TOLEDO CITY PLAN COMMISSION

REPORT

February 9, 2023

LANDSCAPE PLAN

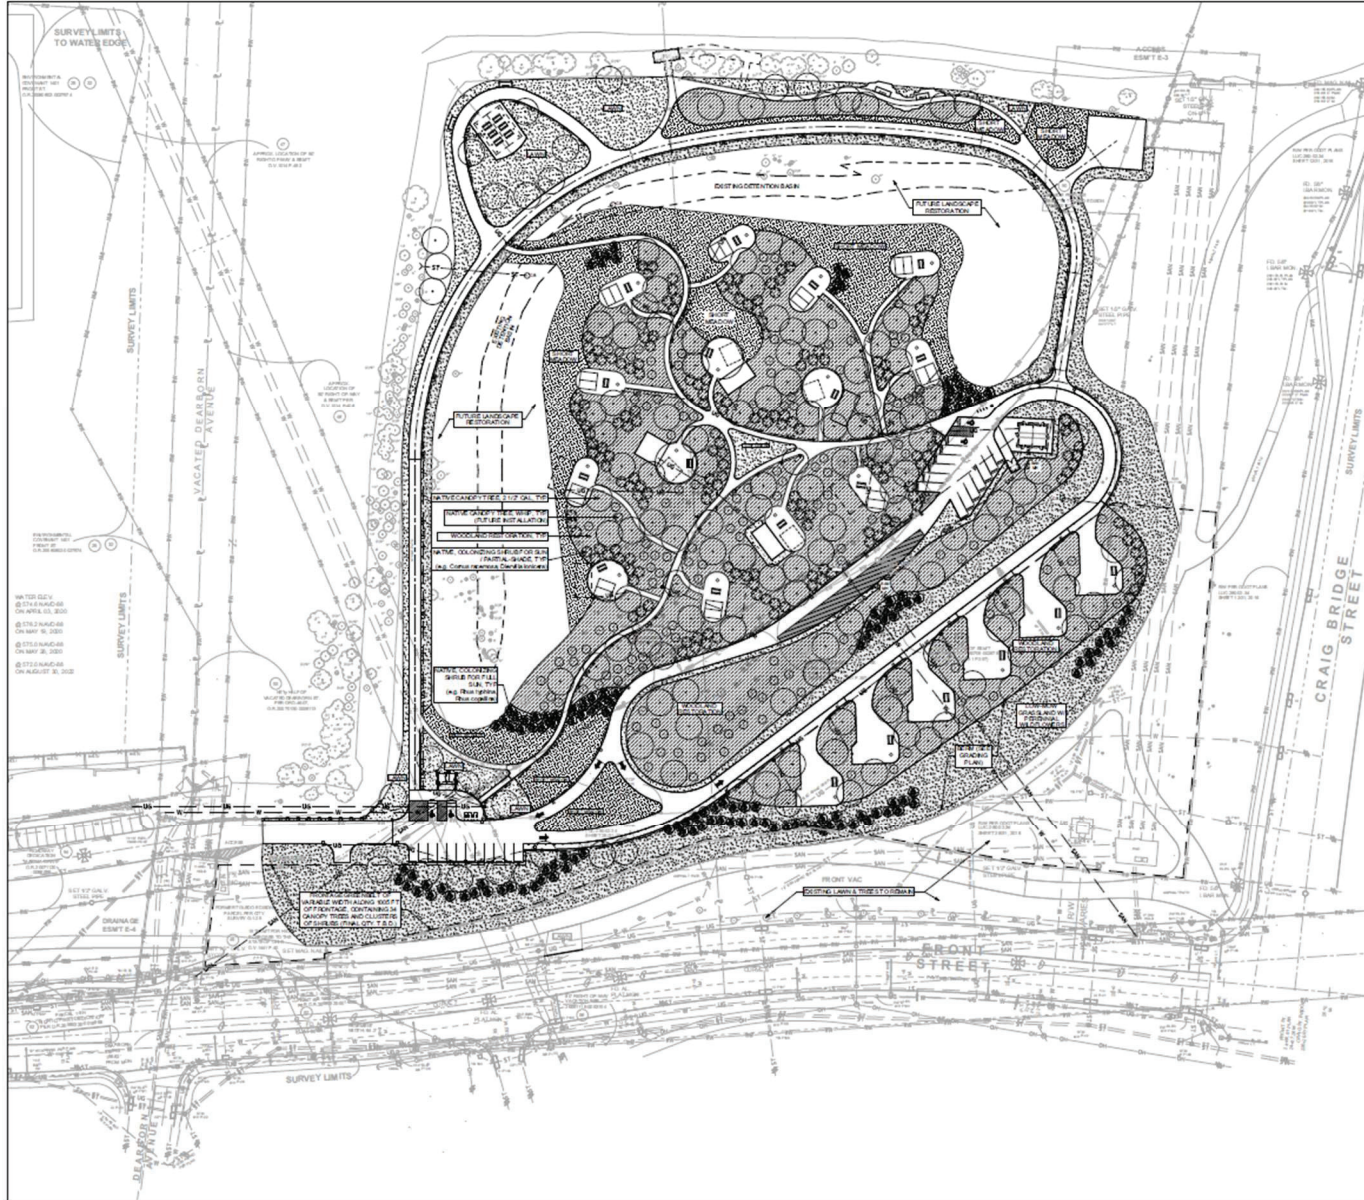
The submitted landscape plan depicts various plantings and botanical features throughout the site. A frontage greenbelt of containing thirty-four (34) canopy trees and clusters of shrubs was provided. The campgrounds are well landscaped with native canopy trees, several varieties of prairie mixes, as well as areas to be dedicated to landscape restoration. A landscape berm will buffer the campgrounds from Front Street and Craig Bridge Street. Staff approves of the landscape plan.

SITE PLAN

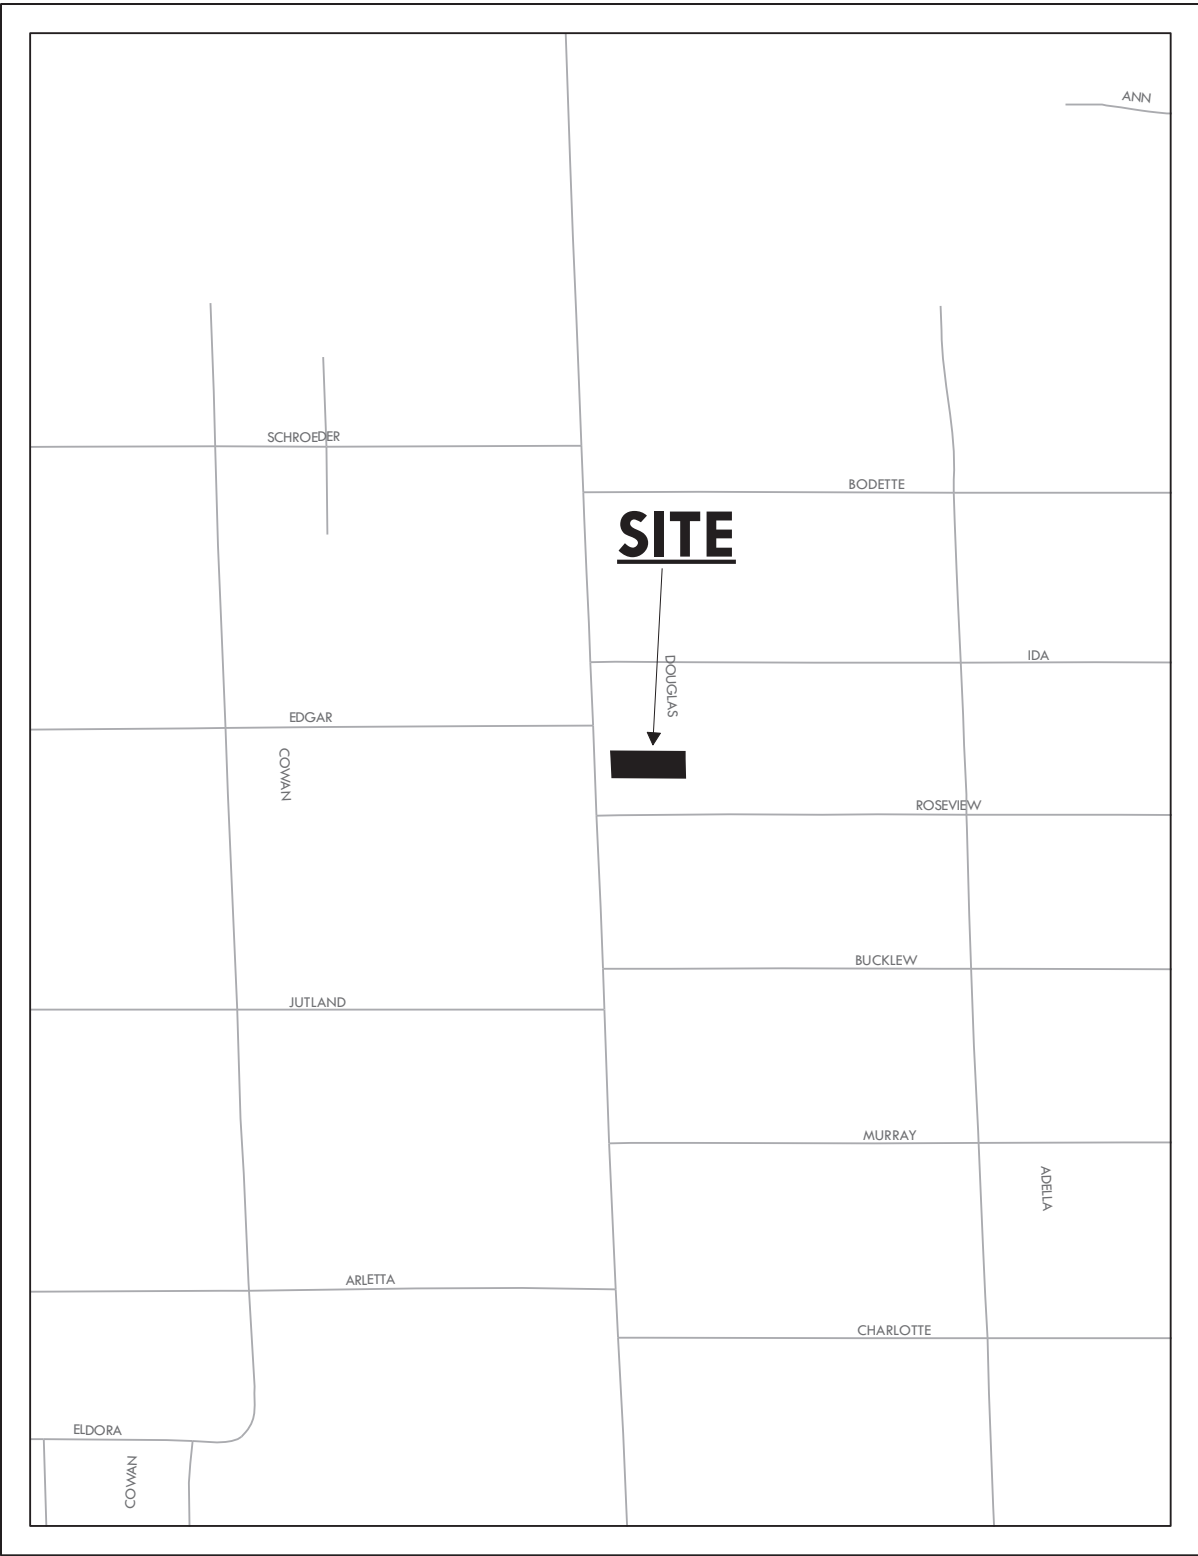
screen the area. The submitted site plan shows one (1) existing tree on property instead of four (4) understory trees. Applicant has the option to request credit for the existing tree under **TMC§1108.0407(B)**. This concern shall be corrected on a revised site plan.

16. Thirty-five (35) square feet of useable indoor space per person in care must be regularly available to the Type A Day Care. **Acceptable as depicted on site plan.**

17. Sixty (60) square feet of useable outdoor space must be provided for each person in care using the outdoor area at any one time. A Type B landscape buffer shall be provided around the outdoor space. **Acceptable as depicted on site plan.**

18. One (1) van accessible parking space shall be required. **Acceptable as depicted on site plan.**
19. A paved off-street area for dropping off and picking up persons in care at the facility must be provided and approved by the Division of Transportation; **Acceptable as depicted on site plan.**

20. TMC 1107.1202.A.1 *Parking Setbacks – Residential Districts*, which prohibits the location of parking spaces within the front yard (other than a driveway), shall be waived to permit the parking spaces as shown on the site plan.
